International Aero Engines SERVICE BULLETIN

ENGINE - HP COMPRESSOR - INTRODUCE A NEW
STAGE 12 LH LOCKING BLADE WITH AN
INCREASED PLATFORM CROP

Dec.12/94

V2500-ENG-72-0204

Figure 1

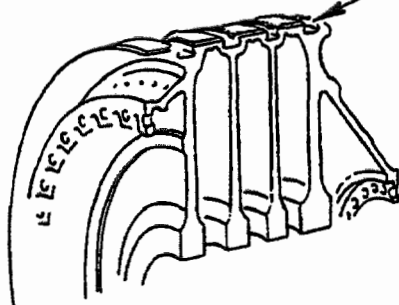
REMOVE 6A4729 STAGE 12
LH LOCKING BLADE AND INSTALL
6A5947 STAGE 12 LH LOCKING
BLADE

Figure 2

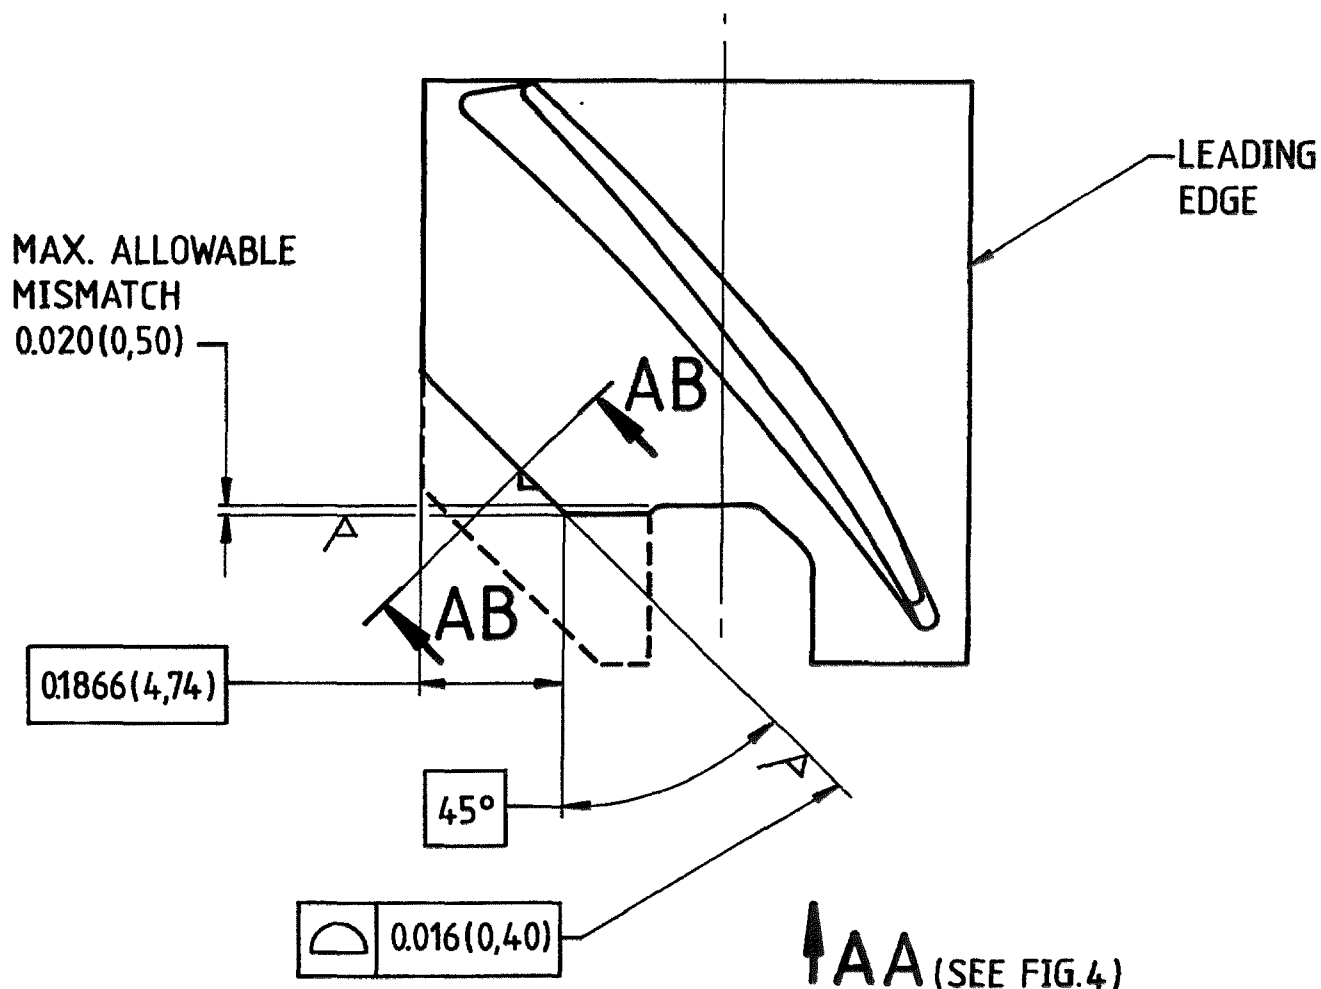
- (e) Grind back the rotor blade(s) platform, where shown
- Refer to Figures 2 and 4.
Use a grinding machine.

Reworking of Existing HP Compressor
Stage 12 LH Locking Blades

ALL DIMENSIONS ARE IN INCHES(MILLIMETRES).
ANGULAR DIMENSIONS ARE IN DEGREES AND DECIMAL PARTS OF A DEGREE.
MACHINE SURFACE FINISH TO BE 125 MICROINCHES(3,2 MICROINCHES) U.O.S.
MACHINE WHERE MARKED ✓
BREAK SHARP EDGES 0.012(0,30)±0.008(0,20) U.O.S.

Figure 3

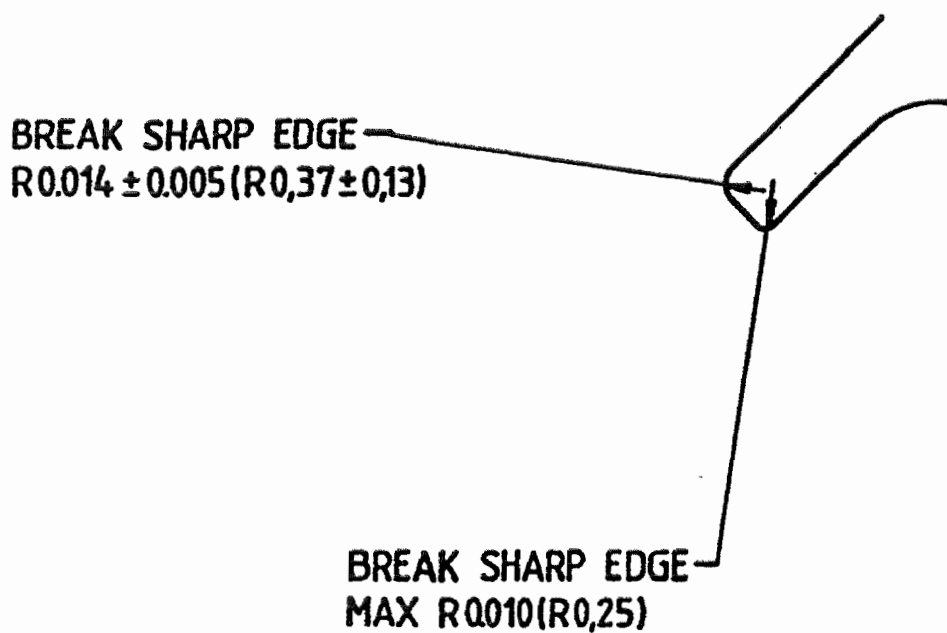
- | (f) Remove sharp edges | Refer to Figures 2, 3 and 4.
Use standard workshop equipment. | | | | |
|--|---|---------------------|---------------------|--------|--------|
| (g) Cold ferric chloride etch the repaired area | Refer to SPM TASK 70-11-39-300-503, SUBTASK 70-11-39-300-001.
Use chemical cleaning equipment. | | | | |
| (h) Do a local penetrant crack test on the repaired area | Refer to SPM TASK 70-23-05-230-501.
Use CoMat 06-022 fluorescent penetrant, with penetrant crack test equipment.
Cracks are not permitted | | | | |
| (i) Measure the dimensions | Refer to Figures 2, 3 and 4. | | | | |
| (j) Cancel the old part number and identify with the new part number | <table border="0"> <thead> <tr> <th><u>OLD PART NO.</u></th> <th><u>NEW PART NO.</u></th> </tr> </thead> <tbody> <tr> <td>6A4729</td> <td>6A5947</td> </tr> </tbody> </table> <p>Refer to SPM TASK 70-09-00-400-501, SUBTASK 70-09-00-400-001.
Use vibro-engraving equipment.</p> | <u>OLD PART NO.</u> | <u>NEW PART NO.</u> | 6A4729 | 6A5947 |
| <u>OLD PART NO.</u> | <u>NEW PART NO.</u> | | | | |
| 6A4729 | 6A5947 | | | | |

Section AB (See Figure 2)

Figure 4

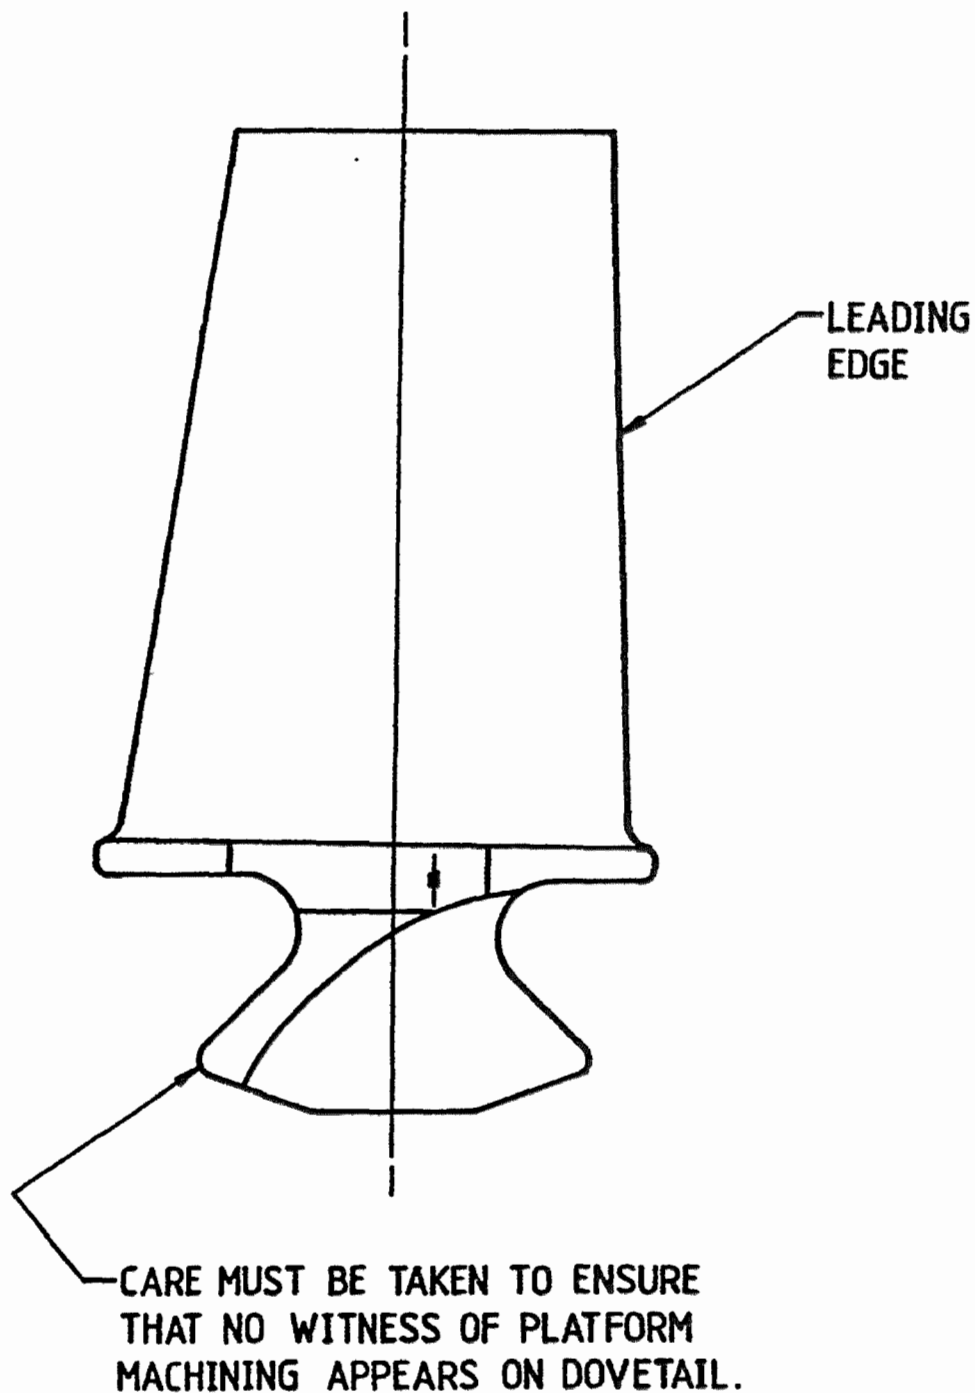
View on Arrow AA (See Figure 2)
